# UNITED STATES PATENT AND TRADEMARK OFFICE

APPLICATION NO.	FILING DATE	FIRST NAMED INVENTOR	ATTORNEY DOCKET NO.	CONFIRMATION NO.
10/612,918	07/07/2003	Kelly F. Williams	91429MGB	6941

## Office Action Summary

## **DETAILED ACTION**

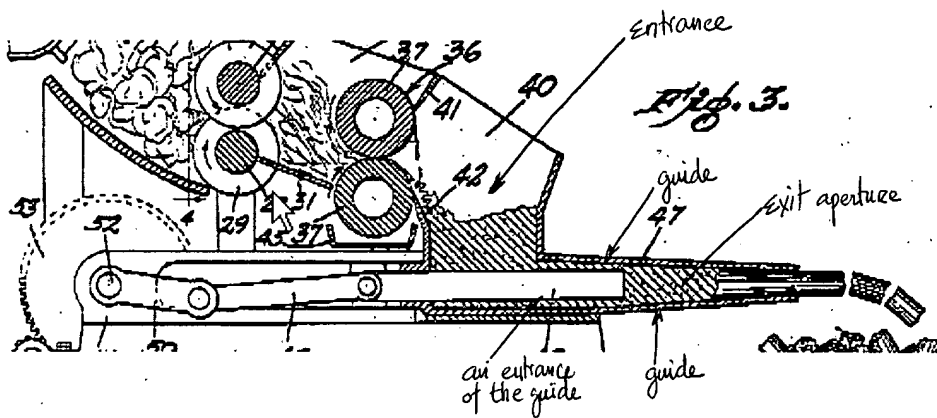
Regarding claim 1, Paxton discloses a compactor comprising: an elongate compression chamber having an entrance and an exit aperture (see the illustration below); a pair of opposing input rollers (37) located at the entrance to the pre-compression chamber, at least one of the rollers provided with rotational drive (page 2, lines 12-14); a moveable plunger (48) operable to sweep a volume of the pre-compression chamber between the entrance and the exit. Note that the limitation “slipsheet” is not positively claimed and it is being claimed as an intended use. Paxton discloses the compactor as claimed as set forth above; therefore, the compactor is capable of compacting slipsheet.

Regarding claim 2, the pre-compression chamber has a transverse cross section that is inwardly tapered towards the exit aperture (see the illustration above).

Regarding claim 3, the pre-compression chamber comprises a pair of spaced apart guides defining a passageway having an entrance at one end thereof and defining the exit aperture at the other end thereof, the passageway inwardly tapered at least in a portion in proximity to the exit aperture (see illustration above).
